JRPP No.	2011SYW027
DA Number	DA-76/2011
Local Government Area	Bankstown City Council
Proposed Development	Demolition of the existing dwellings and associated site structures and the construction of a part two / part three storey residential flat building development containing 144 dwellings with basement car parking, an internal road and strata subdivision pursuant to the provisions contained in <i>State Environmental Planning Policy (Affordable Rental Housing) 2009</i> .
Street Address	81 to 95 Boronia Road, Greenacre
Applicant	Creative Planning Solutions Pty Limited
Owner	GPV Investments Pty Limited
Number of Submissions	283
Recommendation	Refusal
Report by	Ray Lawlor, Development Assessment Officer, City Planning and Environment

SUMMARY REPORT

ATTACHMENT A - DEVELOPMENT APPLICATION ASSESSMENT REPORT

DA-76/2011 (2011SYW027)

Figure 4: Relationship of balconies and decks to neighbouring properties

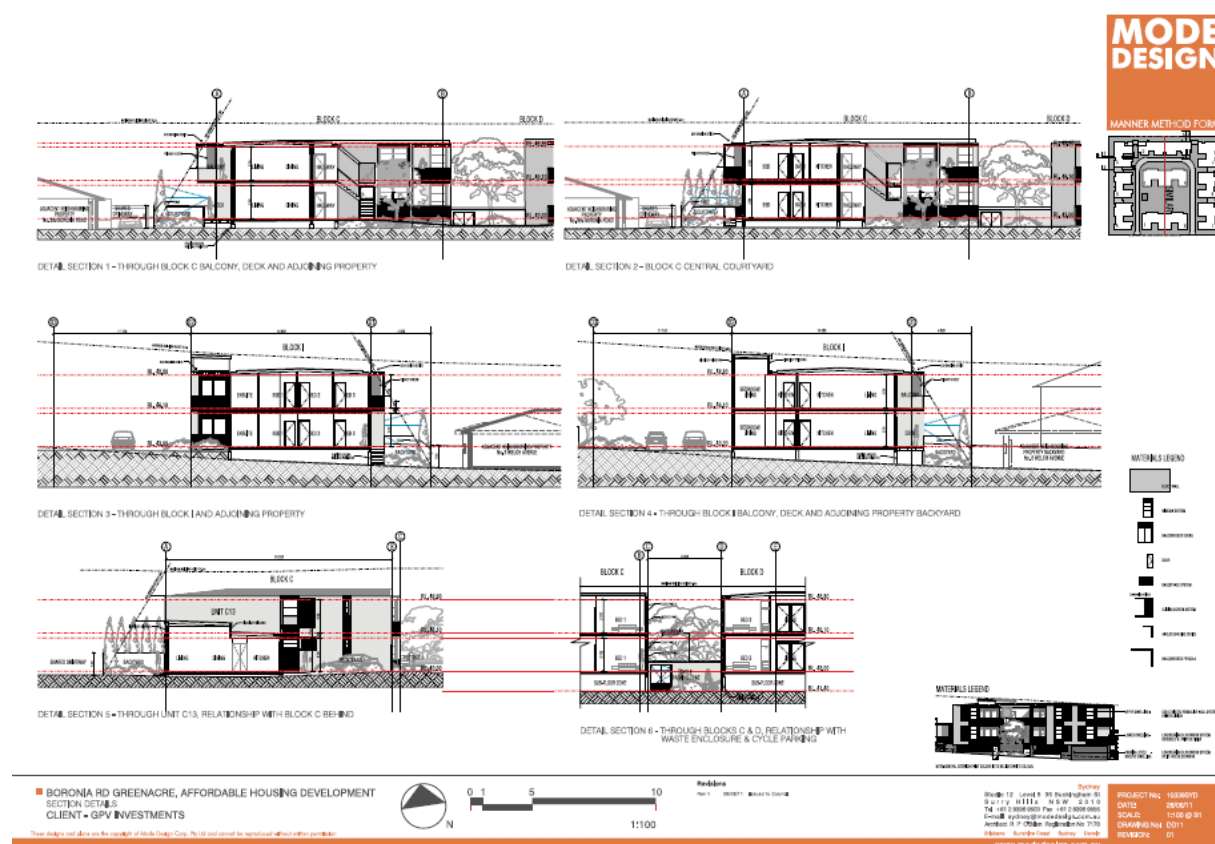
To reduce overlooking impacts, the application was amended, on 29 June 2011, with decks for lower level dwellings reduced in size and depth, in particular, adjacent to the site boundaries with 6 Welch Ave and 99 Boronia Road. These elevated decks would previously have been as close as approximately 1.5m to the side and rear boundaries, they now are proposed to be approximately 3.5m to 4m off the boundaries, with decks elevated up to 1.5m along the rear or northern elevation and up to 1m to 2m for decks along the side elevations. Privacy screens are also to be provided and landscaping increased within the areas where there will be potential visual privacy concerns. Amended elevation drawings indicate screening to upper level balconies, not lower level decks. However this screening is only approximately 1.2m wide and would not necessarily restrict overlooking for all of the balcony areas. No amended landscaping details or plans have been provided.

The extent of these potential for privacy and overlooking impacts would not be expected if the site were to be developed for villas or town houses in line with the densities and controls within Bankstown LEP 2001 and Bankstown DCP 2005, and with single storey development at the rear of the site.

Amended plans have provided for a reduction in the size and depth of decks, particularly where these would impact on the neighbouring dwellings at 6 Welch Avenue and 99A and 99B Boronia Road. Privacy screens have been added to balconies of dwellings. It is also proposed to increase the density and scale of landscaping where there are potential visual privacy concerns, so as to provide more

established vegetation and screening. The proposed screening would not necessarily restrict overlooking for all the balcony areas. As the screen planting will be provided within the courtyards of the ground level dwellings there is no guarantee that this will be maintained by the future owners or residents of these dwellings. No amended landscaping plans have been provided. Accordingly reduced side and rear setbacks are not supported.

Figure 6: Open space areas

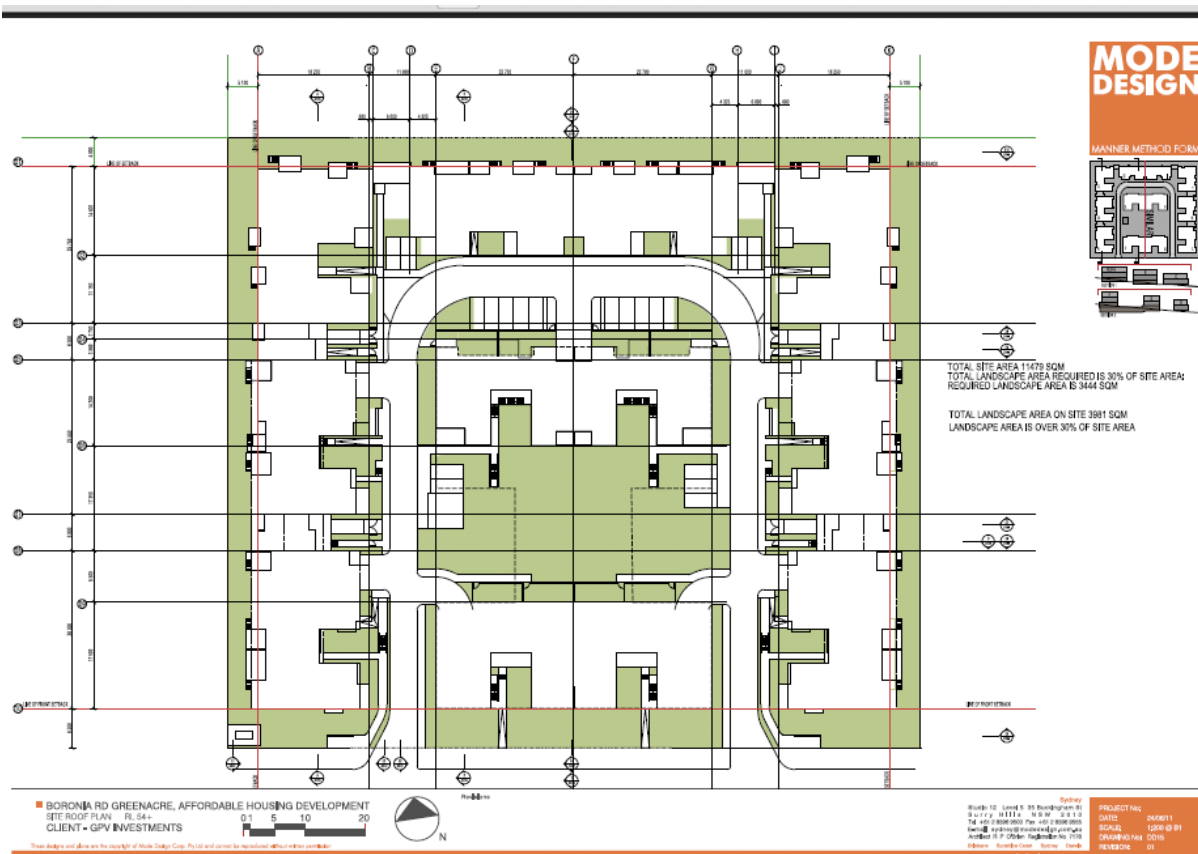
The Design Code recommends that at least 25% to 30% of the site is dedicated to communal open space (between 2869.75sqm to 3443.70sqm). The applicant has indicated that the 'total landscaped area' on the site will be 3981sqm or 34.6%. The central communal open space area, excluding paved access areas, perimeter parking spaces and communal room, has been assessed as being approximately 905sqm, or 7.8% of the site area (of this area approximately 670sqm will be above basement parking with approximately 1m soil depths).

The SEPP 65 statement submitted with the application indicates that the communal open space areas will be approximately 1200sqm. A communal area of 1200sqm represents only 10.45% of the site area.

In support of the proposed communal open space area, the applicant has indicated that the size of the area was consolidated and increased in the preliminary design

Provision of suitable private open space should not detract from the need to also provide for suitable sized and designed communal open space, which will also provide relief between the dwellings and buildings within the development. The provision of suitable private and communal open space areas are both important having regard to the number of dwellings in the proposed development and the number smaller studio and 1 bedroom dwellings. The development should not rely upon existing public open space to compensate for any reductions in suggested communal open space within the development.
